Requested By	Eric Warmbier	Date	4/03/08
Drawing #	T3-2070,2072 thru 2076	Revised From	B To C
Drawing Title	TCS3 Safety Board		
Next Assembly # NA	Telescope		
Next Assembly Title	Telescope		
Reason For Change	Some components were missing in design. Component values needed to be changed based on testing. Minor text and comments were changed in document. Added mods to fix issues.

FROM: (PG2)

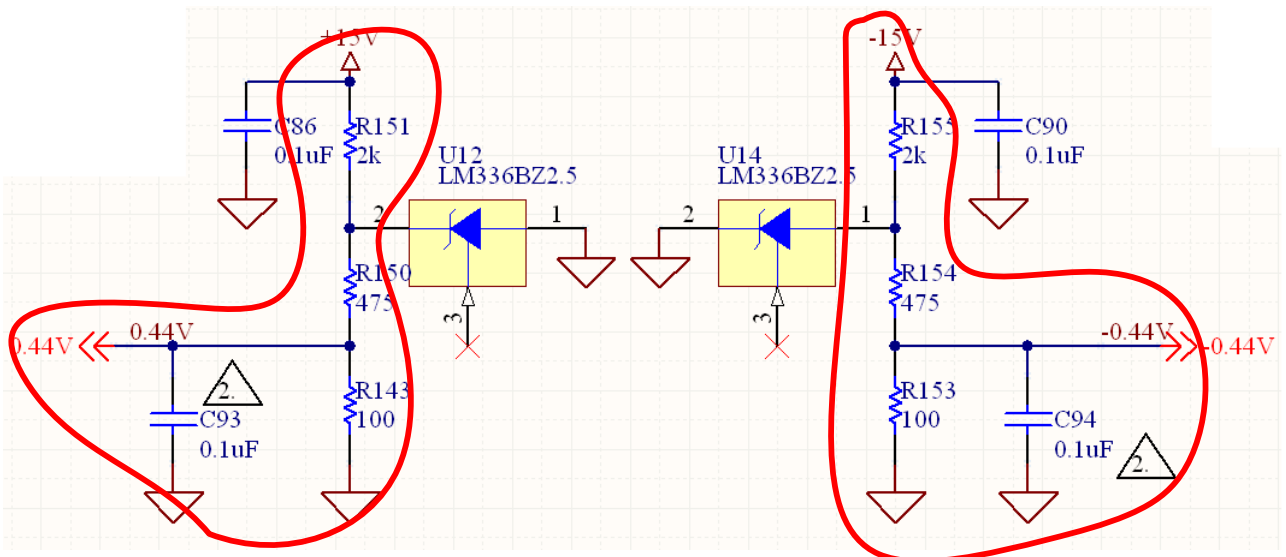
Lower values due to high impedance causing loading issues (reference value not accurate). Lower reference value chosen to be within new negative 0.7V supply on comparators.

Entire +1V and -1V nets changed to 0.44V and -0.44V nets.

FROM: (PG2)

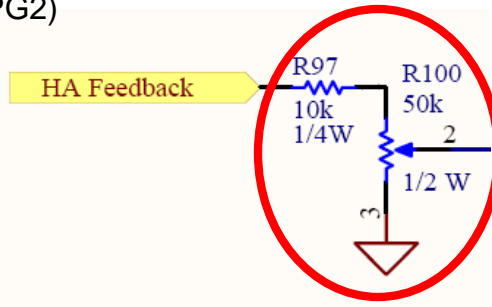
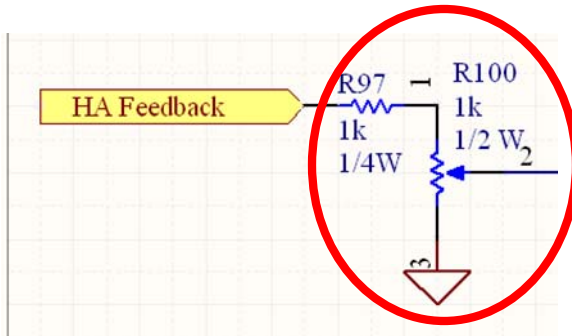
Lower values due to high impedance causing loading issues. Trip points were not symmetrical for negative and positive polarity.

FROM: (PG2)

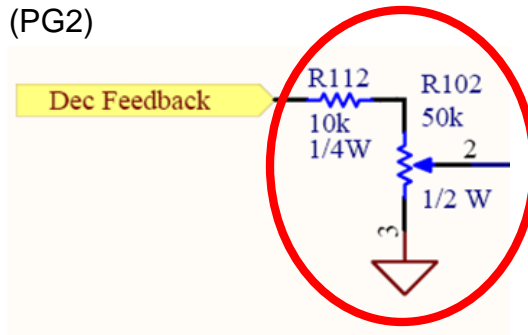
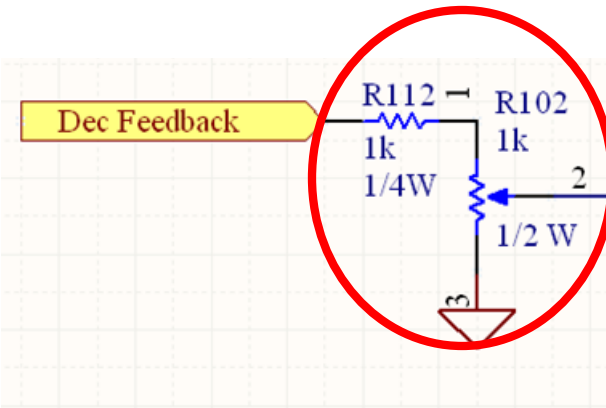
Lower values due to high impedance causing loading issues. Trip points were not symmetrical for negative and positive polarity.

FROM: (PG4, not present)

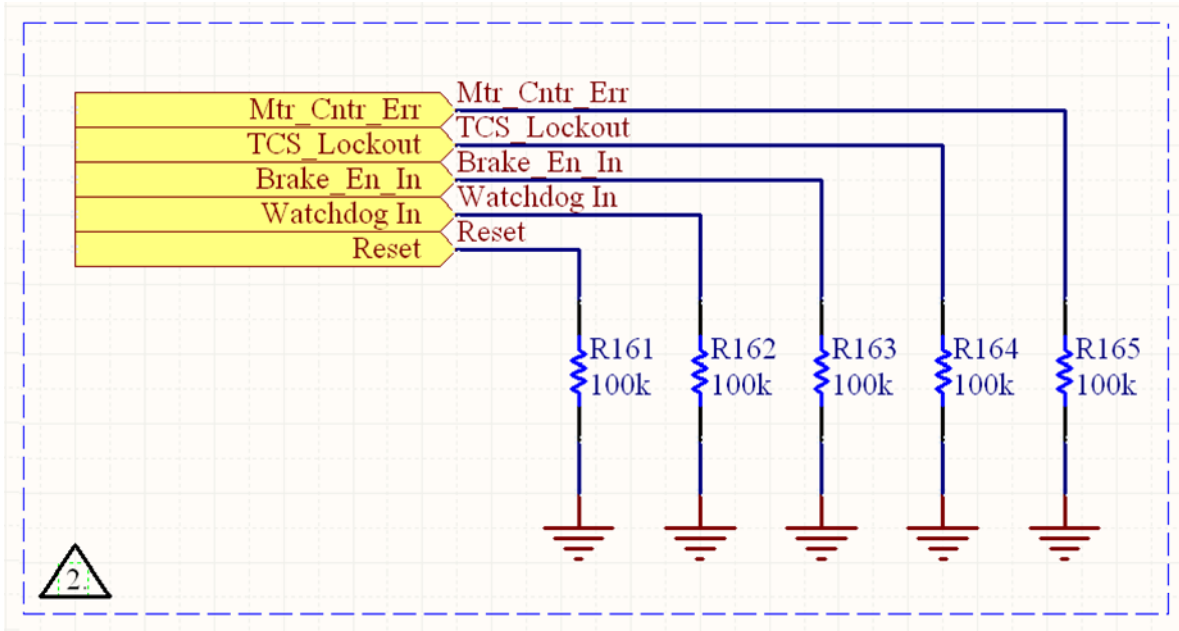
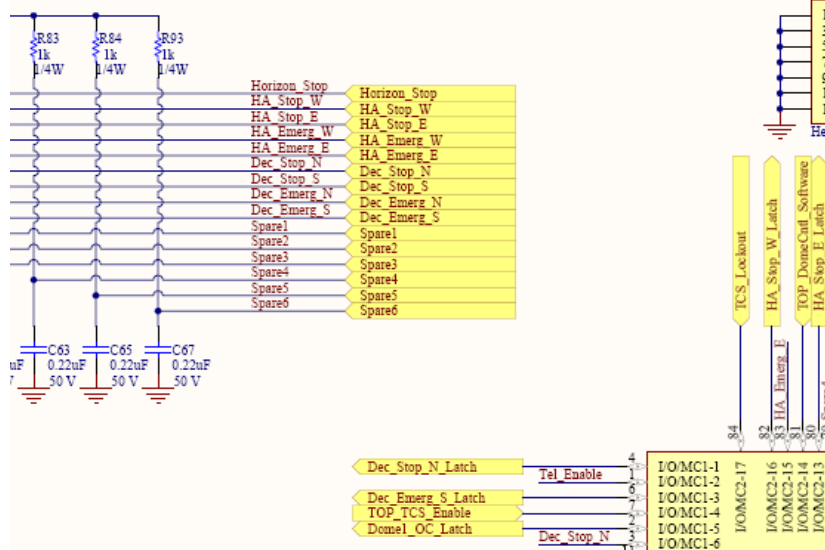
Some of these pins are used in a safety critical way. In the event of a poor connection, they should have a defined, safe state.

FROM: (PG 4)

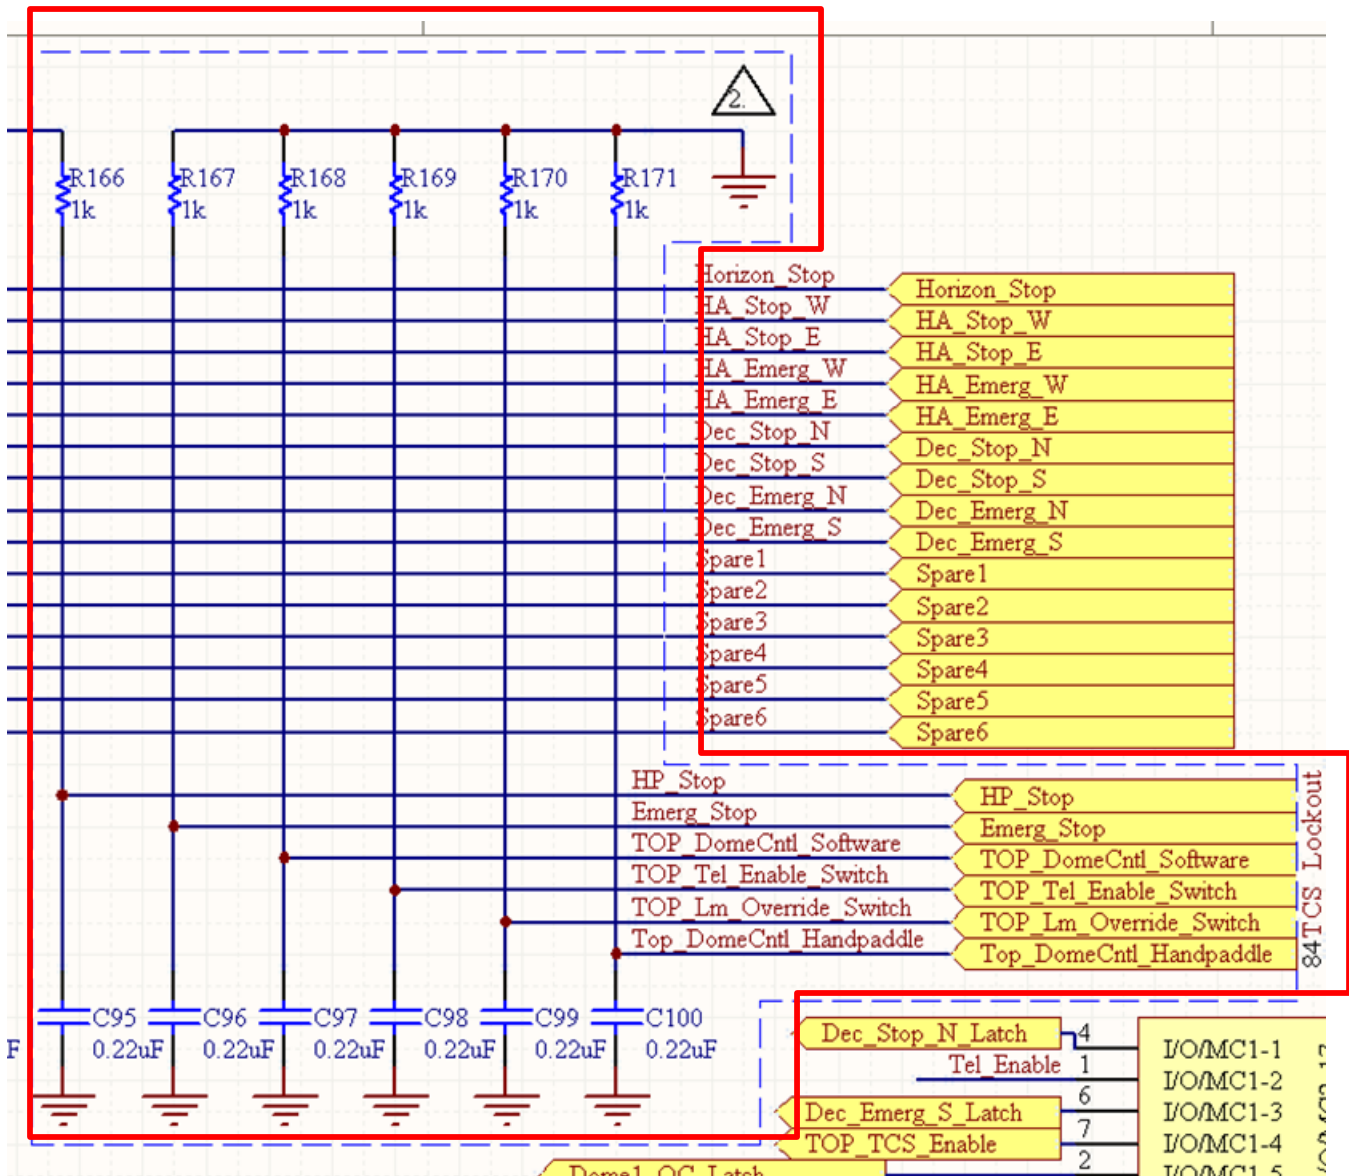
Some of these pins are used in a safety critical way. In the event of a poor connection, they should have a defined, safe state. In addition, they are connected to mechanical switches and should therefore, at a minimum, have some filtering.

FROM: (PG 1)

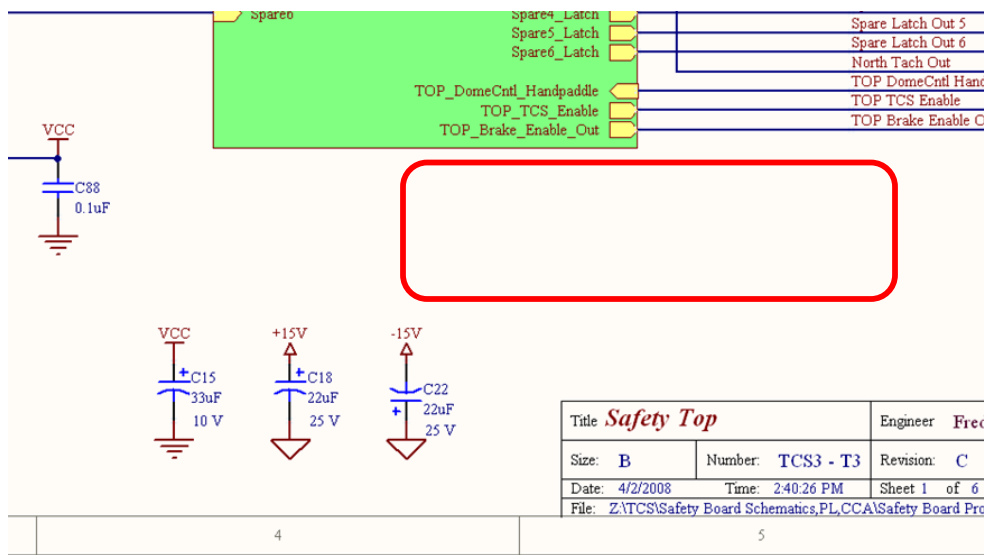
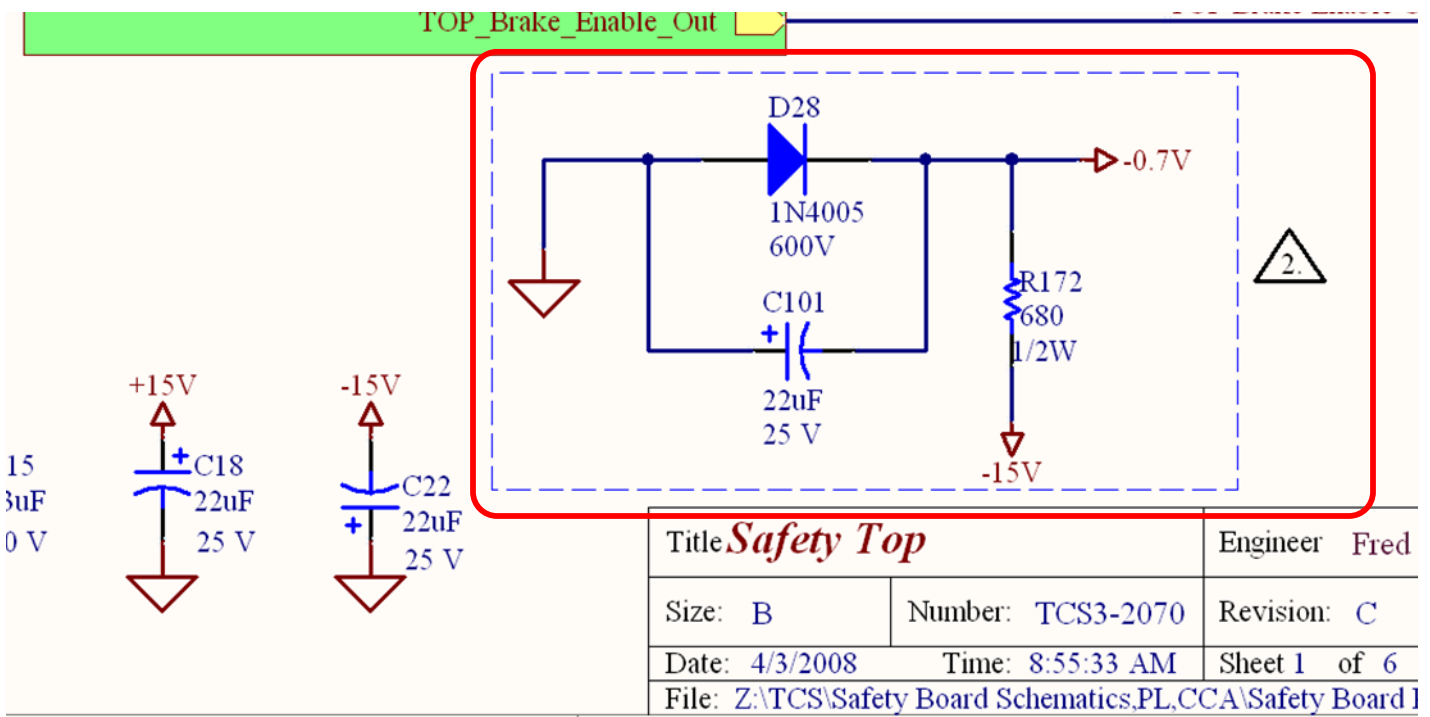
A slightly negative supply needed to be created for only the comparators connected to the CPLD. Comparator negative voltage is now -0.7V. It needed to meet the following:

- 1) Be very simple to add as green wire modification.
- 2) Have a voltage magnitude around -0.5V or so (CPLD min input). Diode is approximately -0.65V. (the saturation output voltage of the comparator is 100 mV+, $-0.65+100mV=-0.55V$).

See T3-2079, Safety Board Hardware Description Document for more details.

FROM: (PG 1,4)

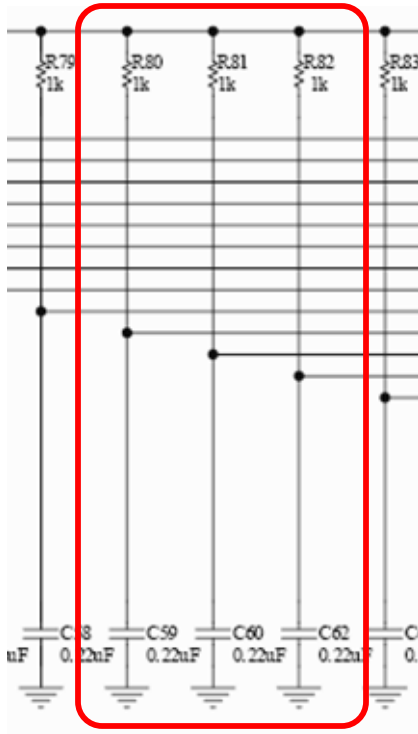
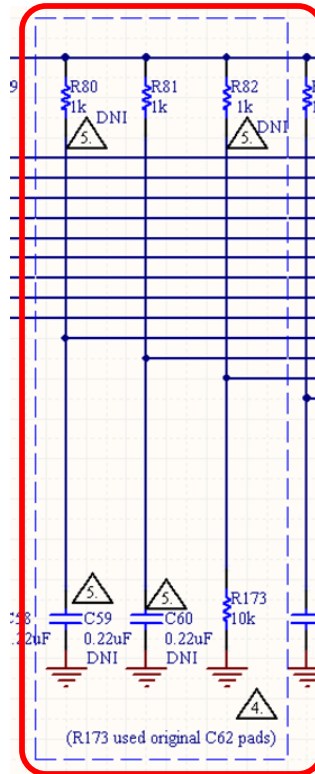
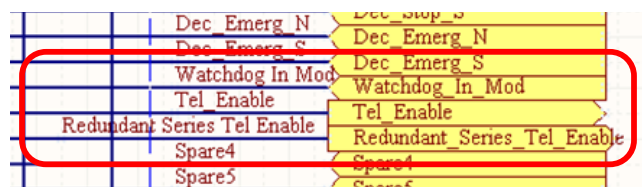
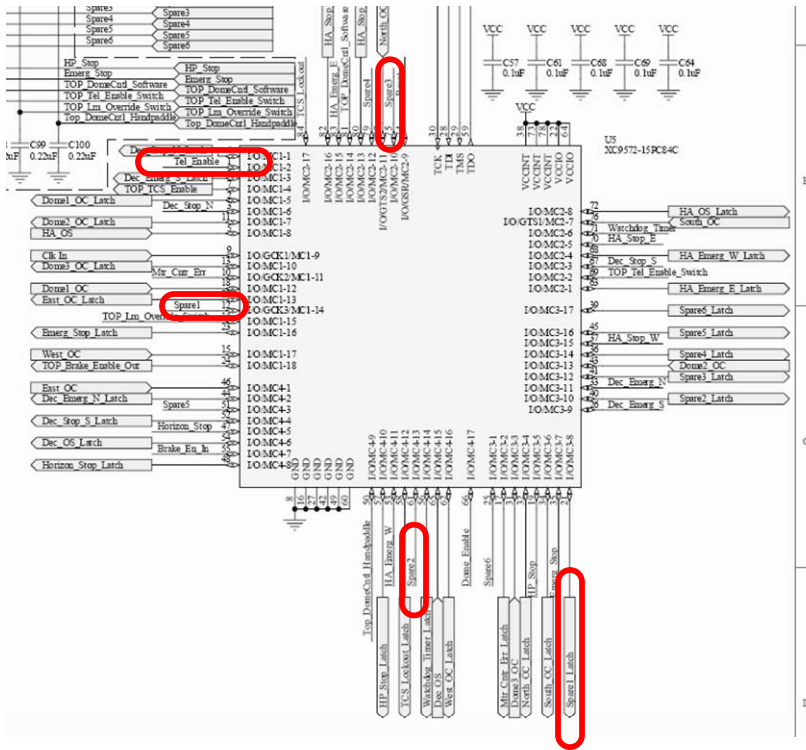
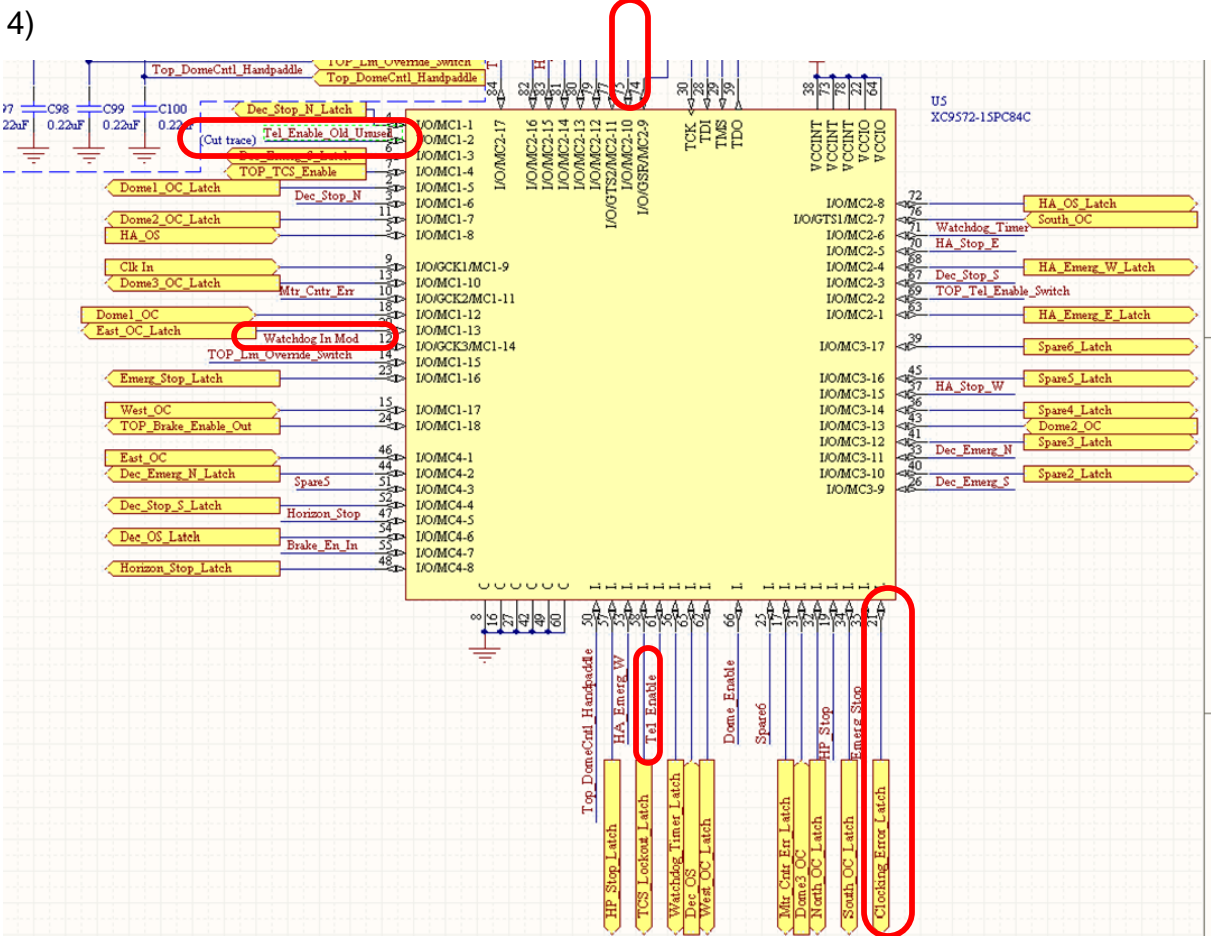
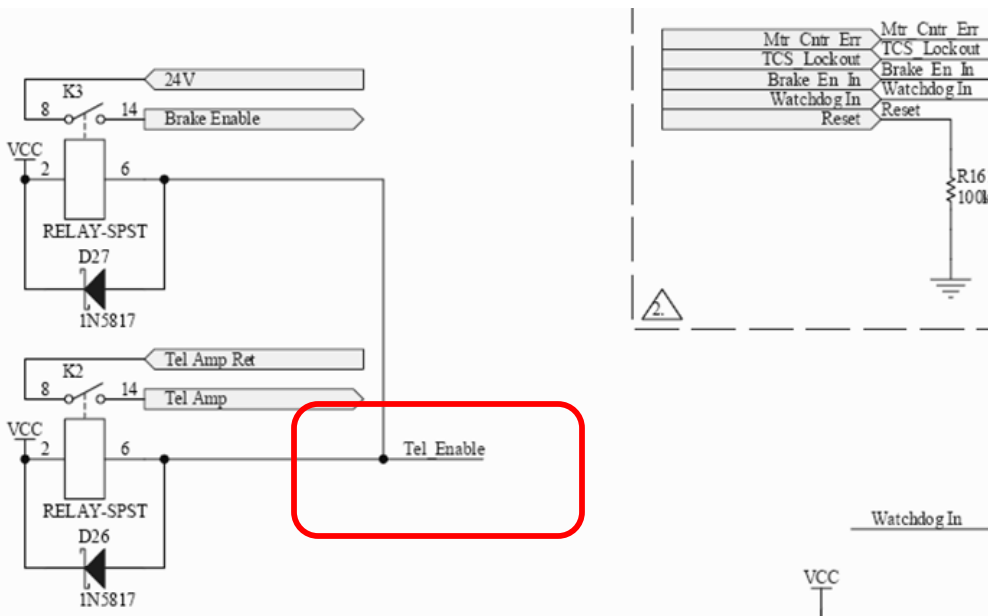
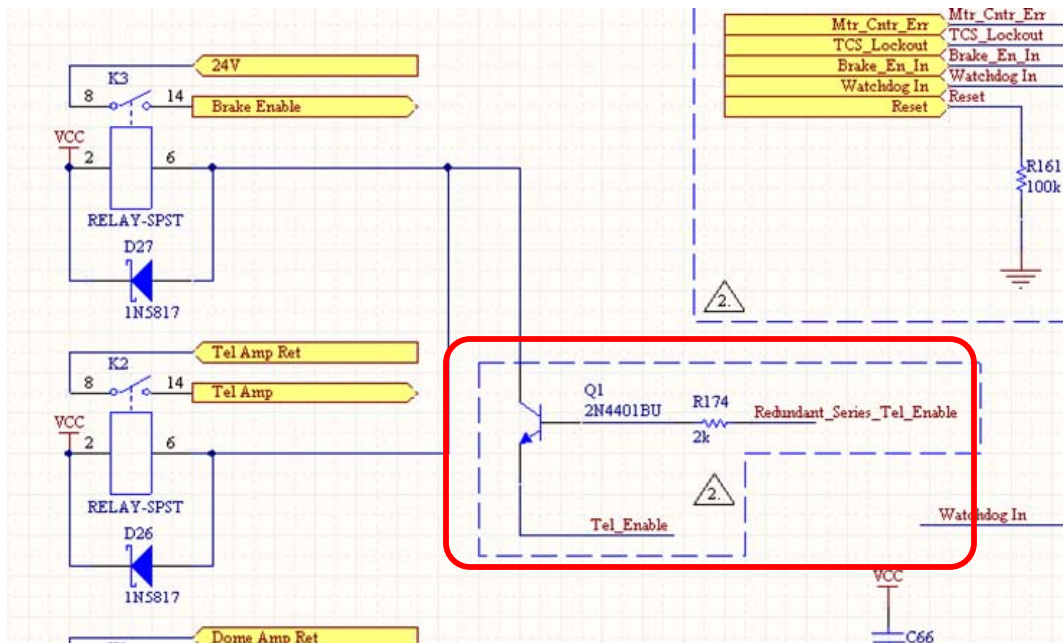
The following signal names changed on sheets 1 and 4:

FROM	TO
Spare1	Watchdog In Mod
Spare2	Tel_Enable
Spare3	Redundant_Series_Tel_Enable
Spare1 Latch	Clocking_Error_Latch
Tel Enable	Tel_Enable_Old_Unused

Spare components and traces were used to make a redundant telescope enable signal driving an in series transistor for increased safety.
